Sandia National Laboratories

August 29, 1984

Subject: Review and Evaluation of the Indian Point 2 Reactor
Vessel UT Indication

Figure 1. Refractive Beam Widths as a Function of a Flat Surface or a Curved Surface.

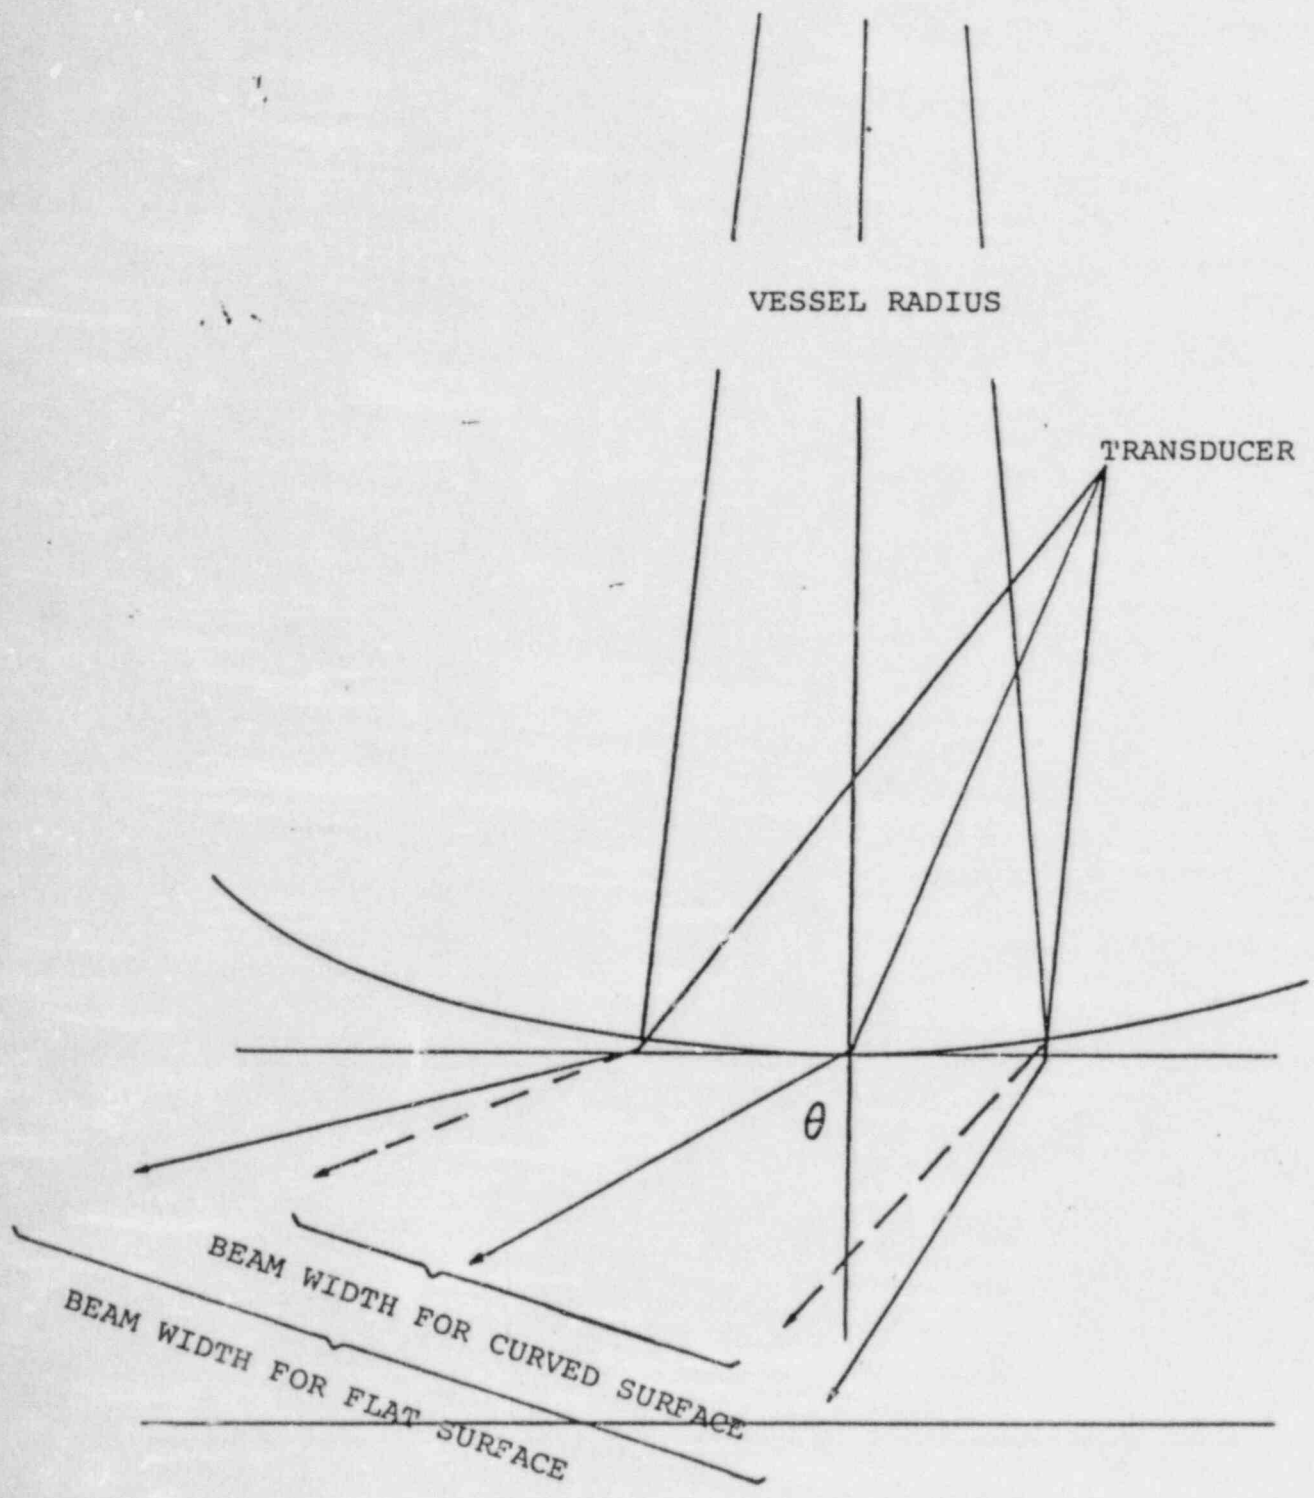
The increased signal is thought to be partly due to the converging lens effect of the ID curvature of the mockup on the broad immersion beam. Figure 1 illustrates the difference in the refracted beam widths due to a flat and curved surface. The measured beam widths given above, however, are in very good agreement which indicates that some other reason for the 30 dB increase in signal is responsible.

FIGURE 2. CRACK THROUGH WALL DEPTH VERSUS TIME INTERVAL RESULTING FROM A TIP DIFFRACTED L-WAVE AT 0 DEGREES FOR INCIDENT S-WAVES AT 45 AND 43.7 DEGREES.

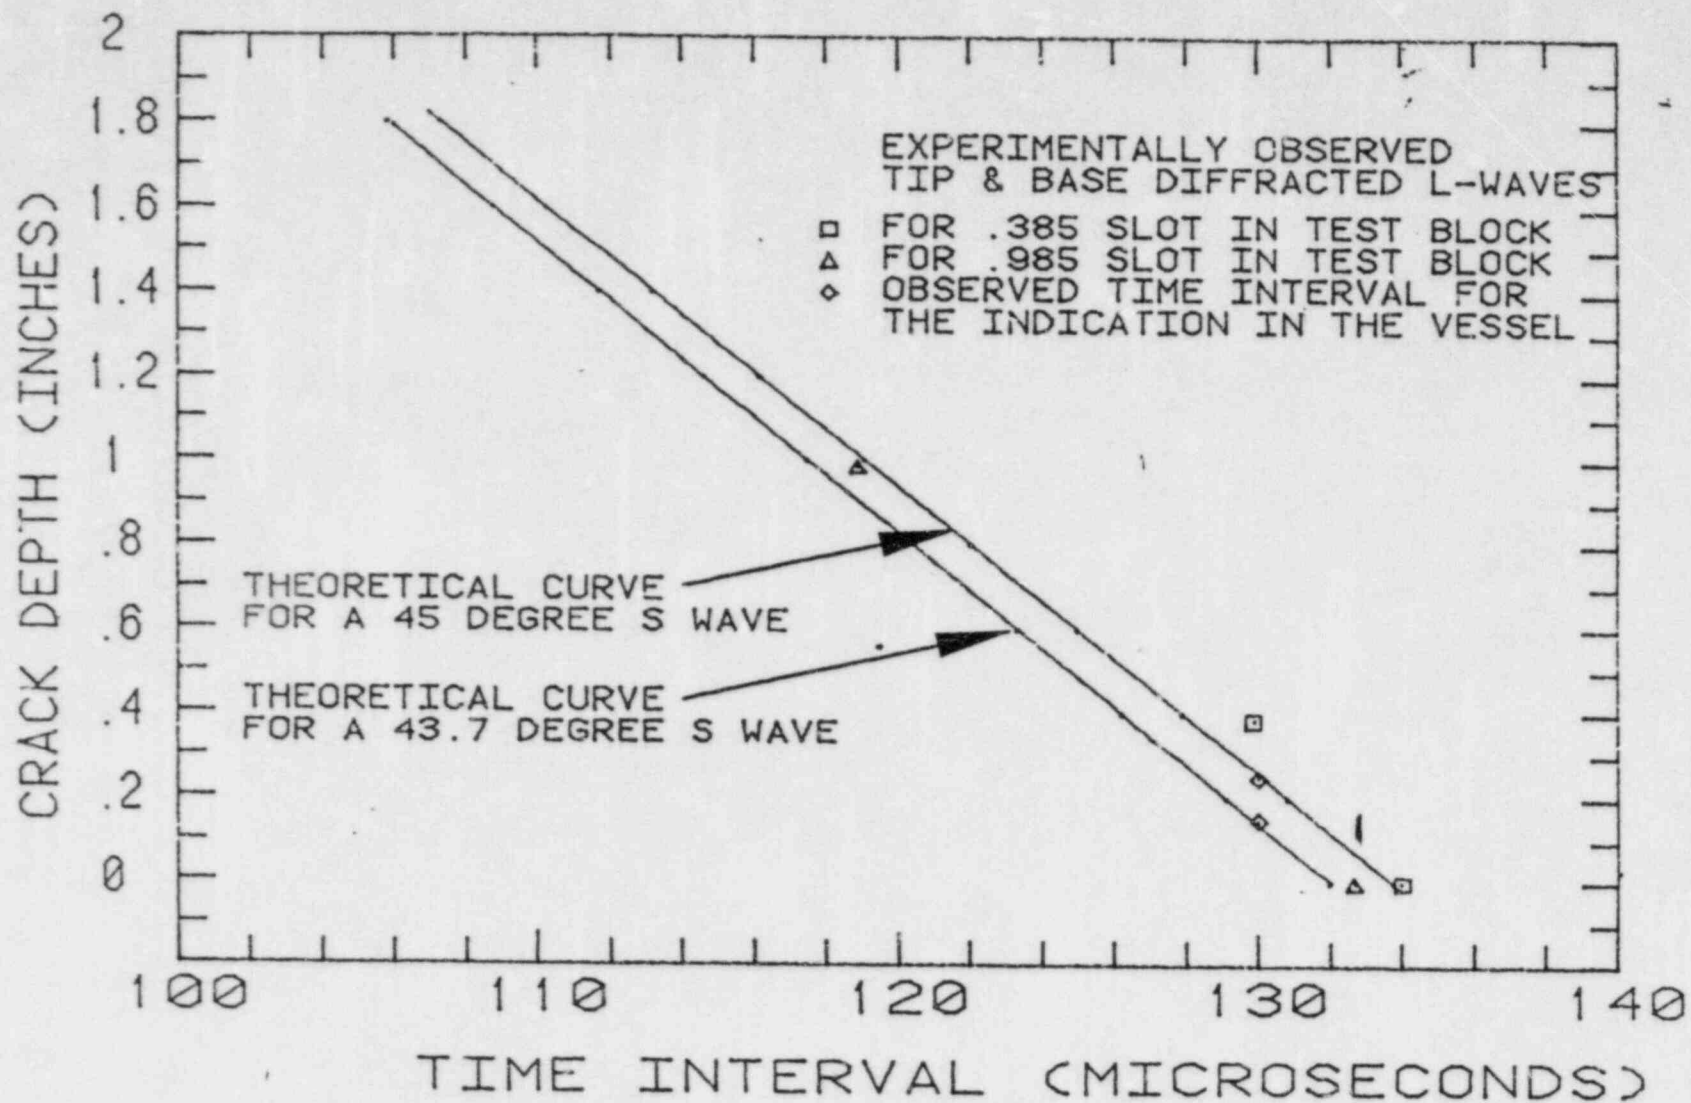
The time interval can be measured to within 0.1 microsecond so that depth information can be potentially determined to within 0.01 inch. Knowing the exact geometry of beam angle, vessel thickness, and determining the water path delay accurately, may be the greatest sources of error. The demonstration was set up in a hurry and some of these factors may have influenced the time interval measurements of the slots. The main purpose of the demonstration was to experimentally show NRC and consultants that the tip diffracted L-wave was present and could be used to make depth measurements of the crack indication in the vessel. Even so, the determined slot depths by this technique for the demonstration were in good agreement with actual values as shown in Figure 2.

Assuming that an ideal geometry is known for the vessel indication, the crack depth for the observed shortest time interval measurement of 130.0 microseconds is 0.14 inches for a 43.7 degree S-wave and 0.26 inches for a 45 degree S-wave. Therefore, the 0.3 inch depth evaluation by Westinghouse is valid.

Figure 3. Geometry of the Delta and Pitch -Catch Techniques.

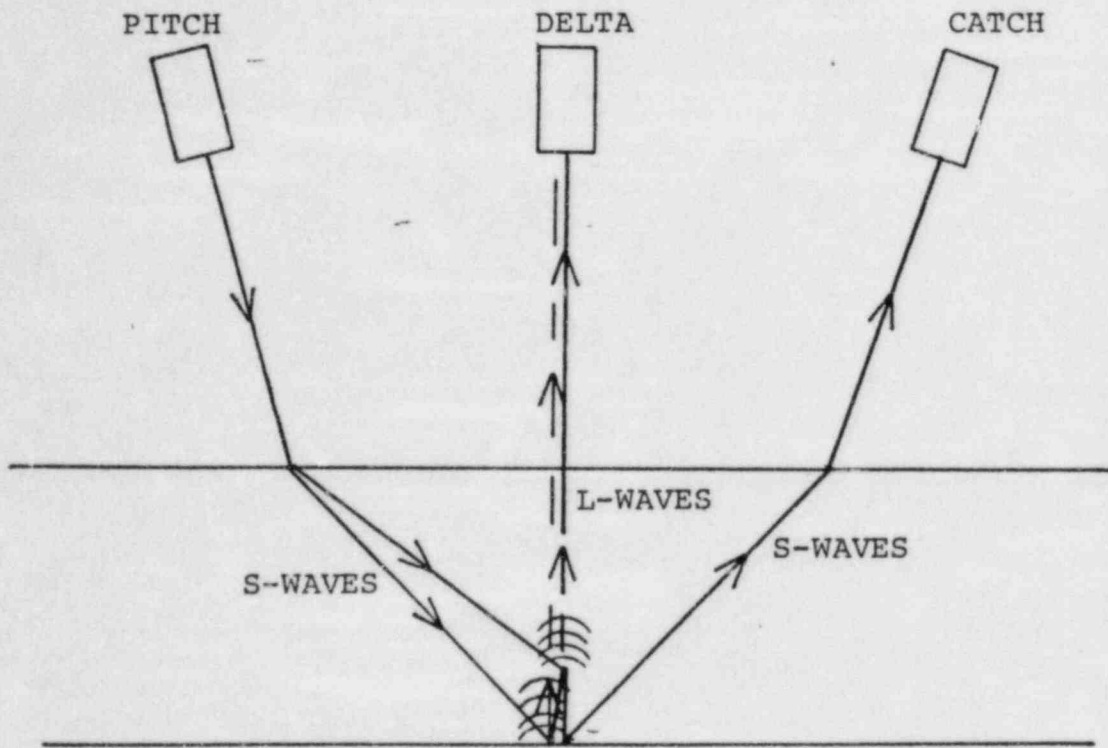
of operation which is also illustrated in Figure 3. This demonstration verified that a significant reduction of the received signal was observed (100% to 15%) as the beam traversed the 0.985 depth slot and only a slight reduction was observed as the 0.385 depth slot was scanned. However, shadowing of the signal during the vessel examination was inconclusive since similar amplitude reductions were observed in locations away from the crack indication and exact positions of the pitch-catch transducers with respect to the crack indication could not be determined from the video tape data. For this demonstration, the 2S time interval measurement was 188.9 microseconds which is in good agreement with the theoretical values of 188.2 for a 9.0 inch thickness and a 43.7 degree angle beam. The theoretical value for a 45 degree angle beam is 191.8 microseconds.
